SUBJECT: REISSUANCE OF THE SEPTEMBER 6, 1991, AMENDMENTS FOR DIABLO CANYON
NUCLEAR POWER PLANT, UNIT NOS. 1 AND 2 (TAC NOS. 80243 AND 80244)

ATTACHMENT TO LICENSE AMENDMENT NOS. 66 AND 65

FACILITY OPERATING LICENSE NOS. DPR-80 AND DPR-82

FIGURE 4.7-1

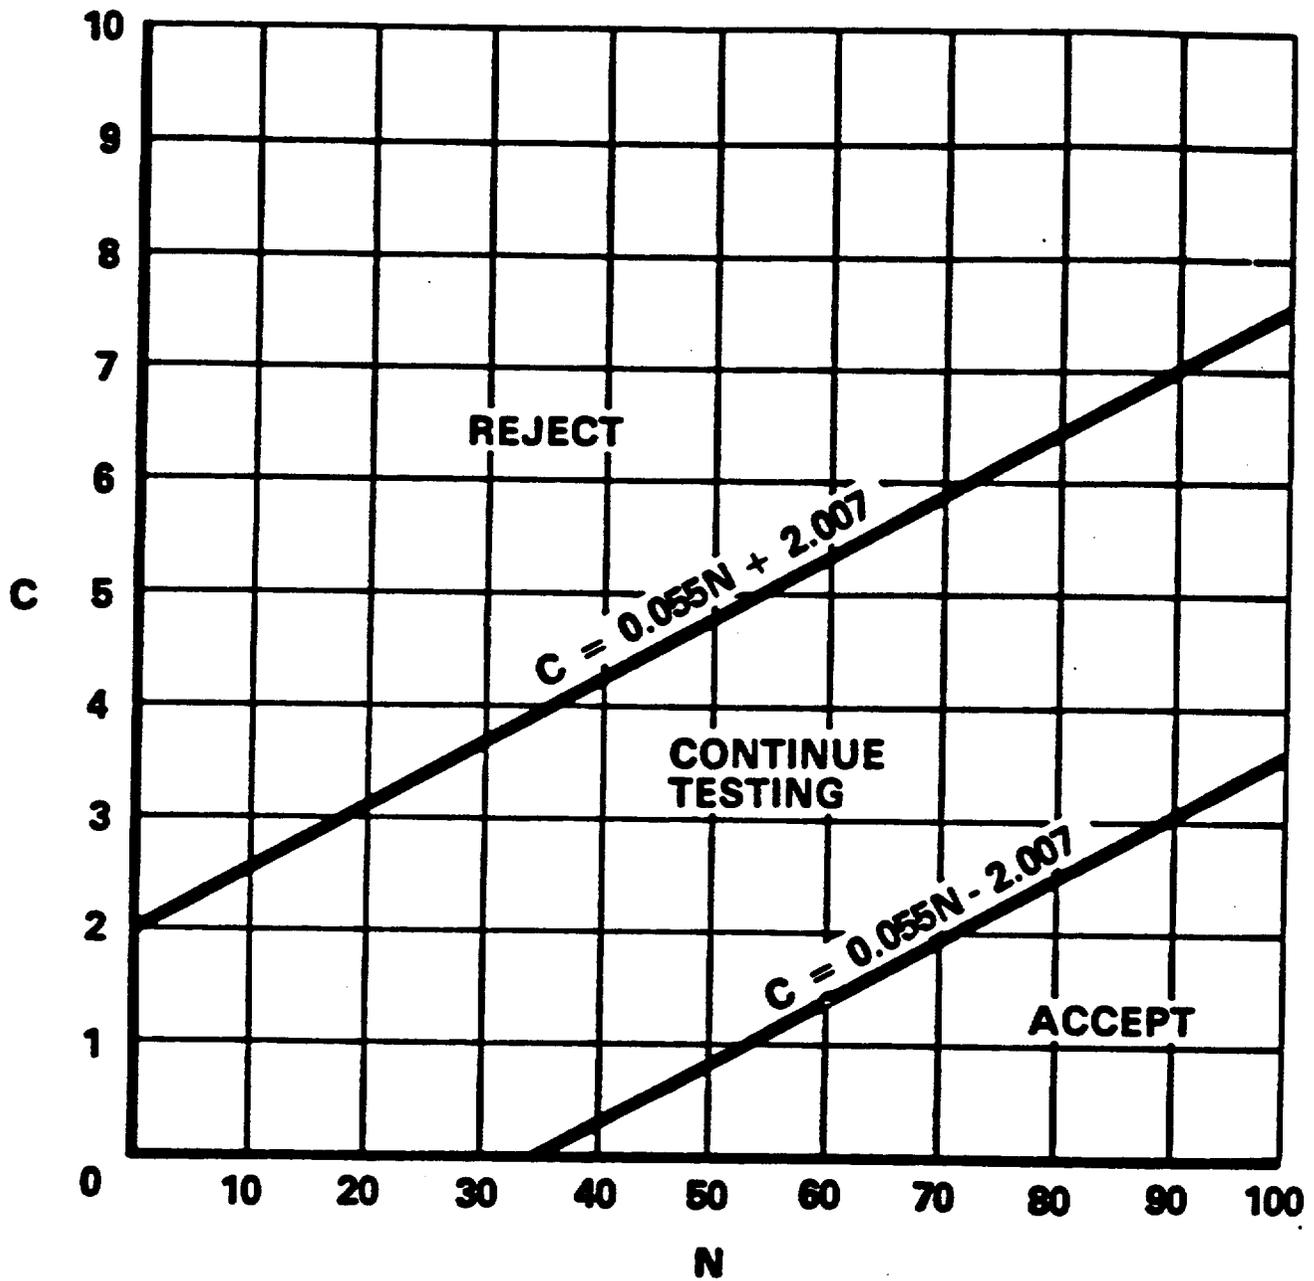
- 2) A representative sample of each type of snubber shall be functionally tested in accordance with Figure 4.7-1. "C" is the total number of snubbers of a type found not meeting the acceptance requirements of Specification 4.7.7.1e. The cumulative number of snubbers of a type tested is denoted by "N". At the end of each day's testing, the new values of "N" and "C" (previous day's total plus current day's increments) shall be plotted on Figure 4.7-1. If at any time the point plotted falls in the "Reject" region, all snubbers of that type shall be functionally tested. If at any time the point plotted falls in the "Accept" region, testing of snubbers of that type may be terminated. When the point plotted lies in the "Continue Testing" region, additional snubbers of that type shall be tested until the point falls in the "Accept" region or the "Reject" region, or all the snubbers of that type have been tested; or
